# **Report to Development Permit Panel**

DP 15-700370

Application by Yamamoto Architecture Inc. for a Development Permit at 9560

Alexandra Road

WEST ELEV.

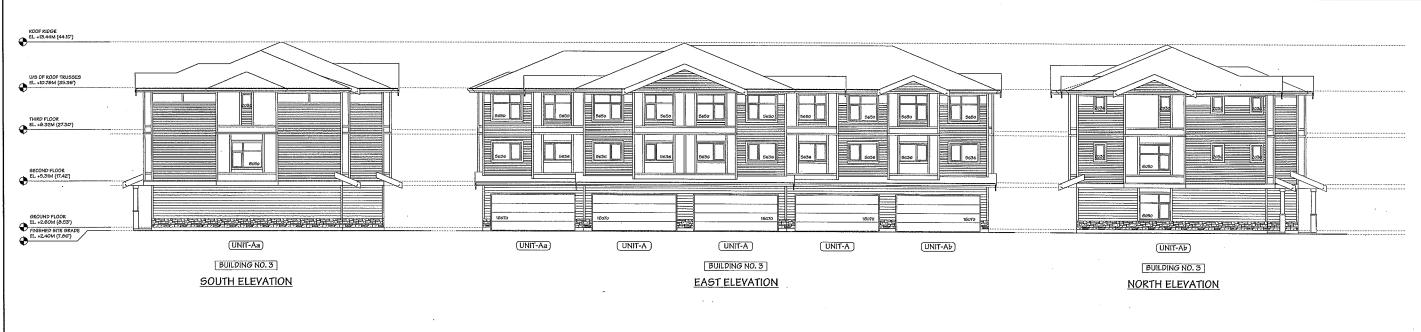
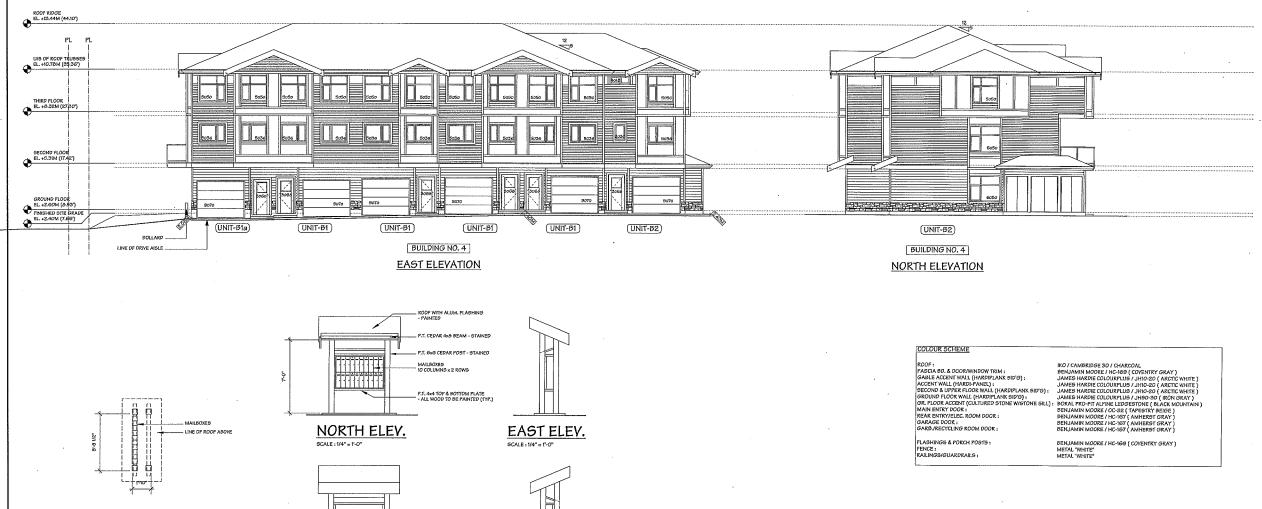
- consider dropping down the architectural element at the top floor of Unit B2a Building No. 1 (west elevation) as it appears heavy on the top; should read like the architectural elements in the upper floors of Building No. 3 units (west elevation); *Elevation revised as per comment*.

L1 DRAWN: DD DESIGN; DD CHK'D; PCM OF 3

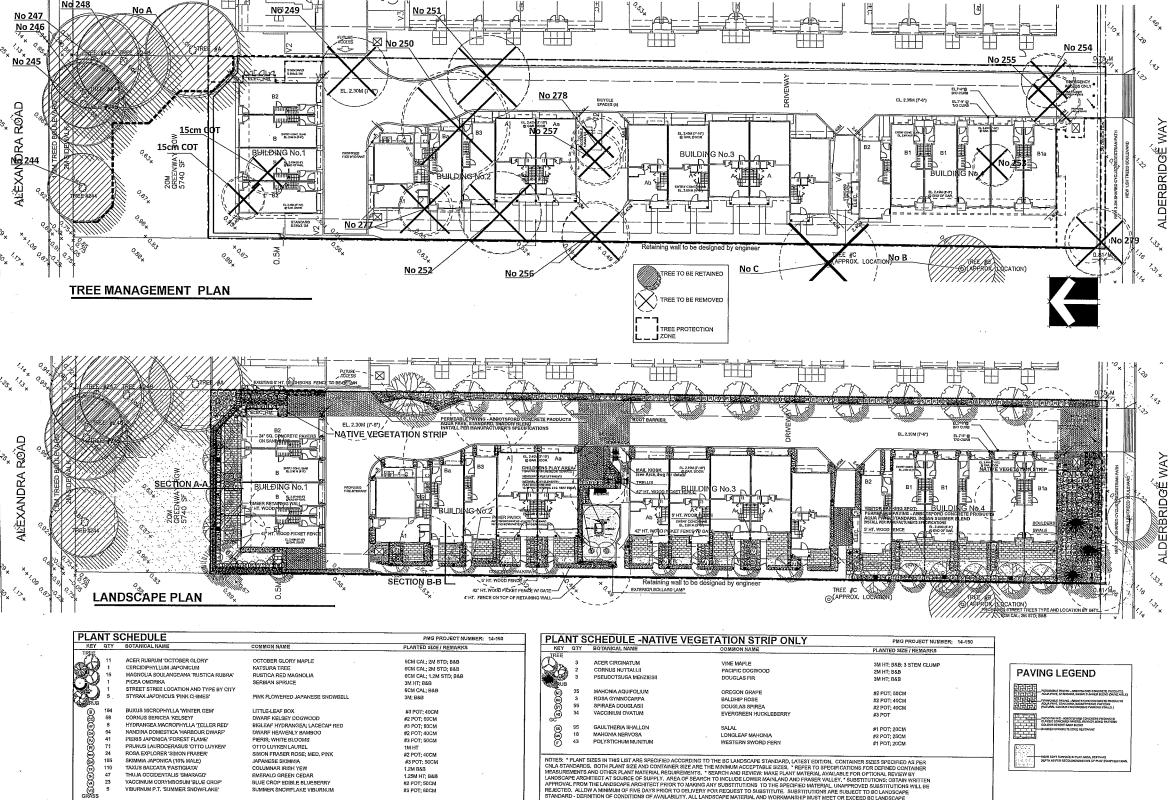
- choice of native plant species is generally good; however, consider replacing the pacific crabapple trees with the more ornamental vine maple trees at the northeast corner of the site; PMG: Pacific Crabapple trees have been replaced with Vine Maple trees at the northeast corner of the site. Please see L1 for your reference.

- appreciate the planting along the internal drive aisle; however, ensure that there is adequate root barrier between the road curb and gutter for the red maple trees; PMG: Root barrier has been added between road curb and gutter for the Red maple trees along internal driveway. Please see L1 for your reference.

- no need to provide lawns for units in Building Nos. 2 and 3 as the proposed location is shady; lawn spaces for Building No. 4 units could be better utilized for the walkway extension; *PMG: Lawns for units in Building No.2 and 3 have been reduced. Please see L1 for your reference.*

- review the need for shrub planting between the walkway and the fence as the space could be utilized to enlarge the unit yards; *PMG: Shrub planting between the walkway and the fence along West P.L. have been removed and the unit yards have been enlarged. Please see L1 for your reference.*

- appreciate the planting in the Alderbridge Way setback; consider adding more conifers such as Douglas firs; *PMG: More Douglas firs have been proposed in the Alderbridge Way setback. Please see L1 for your reference.*
